Access Compliance Report

Public Rights-of-Way

Intersection ID: 44167	Main Street: BRANDYBUCK_LN	Cross Street: COCHRANE_DR	Location: SW
ADA ID: 361C7D9E03F4	Ramp Type: BlendTrans1	Initial Pass/Fail: Fail	Overall Compliance: No
Codes/Mitigation Info/Possible Solution		Field Measurements/Component Compliance	
Severity Score: 17.5

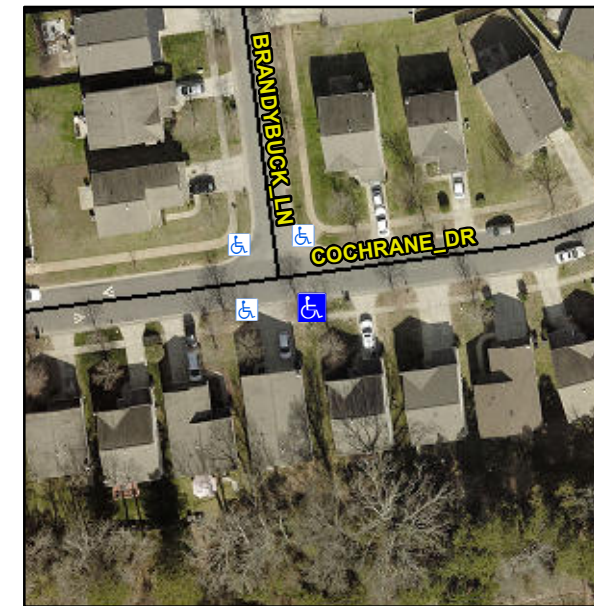
Not Found, R304.5.1

Compliance	Description	Data	Compliance	Description	Data
N/A	Ramp Length (in)	84.5	Yes	BlendTrans Slope (%)	4.8
No	Ramp Width (in)	34.5	Yes	BlendTrans XSlope (%)	1.5
N/A	Flare Type LT	N/A	N/A	Flare Type RT	N/A
N/A	Flare Slope LT (%)	N/A	N/A	Flare Slope RT (%)	N/A
N/A	Flare Traversable LT?	N/A	N/A	Flare Traversable RT?	N/A
N/A	Landing Length (in)	N/A	N/A	DWS Provided?	N/A
N/A	Landing Width (in)	N/A	N/A	DWS Contrast?	N/A
N/A	Landing Slope (%)	N/A	N/A	DWS Length (in)	N/A
N/A	Landing X Slope (%)	N/A	N/A	DWS Full Width?	N/A
N/A	Landing Curb? (Y/N)	N/A	N/A	DWS Offset (in)	N/A
N/A	Shared Landing?	N/A			
N/A	Gutter Ponding?	N/A	N/A	Gutter Slope (%)	N/A
N/A	Gutter Lip Ht (in)	N/A	N/A	Gutter X Slope (%)	N/A
N/A	Painted X Walk1?	No	N/A	Painted X Walk2?	N/A
	X Walk 1 Direction	To N		X Walk 2 Direction	N/A
	X Walk 1 Width (in)	N/A		X Walk 2 Width (in)	N/A
	X Walk 1 Slope (%)	4.0		X Walk 2 Slope (%)	N/A
	X Walk 1 X Slope (%)	1.1		X Walk 2 X Slope (%)	N/A

N/A	Ramp inside XWalk1?	N/A	N/A	Ramp inside XWalk2?	N/A
	Road Slope (%)	1.1		Clear Space?	N/A
	Road X Slope (%)	4.0	N/A	Clear Space to XWalk (in)	N/A
N/A	Any Obstructions?	N/A	N/A	Storm Grate/Utility Hazard?	N/A
	Obstruction Type			Storm Grate/Utility Type	
		N/A			N/A
			Yes	Surface Condition? (G/P)	Good
			No	Curb Slope (%)	13.5

Remove & Replace Curb Ramp With Two New Directional Ramps or Equivalent.
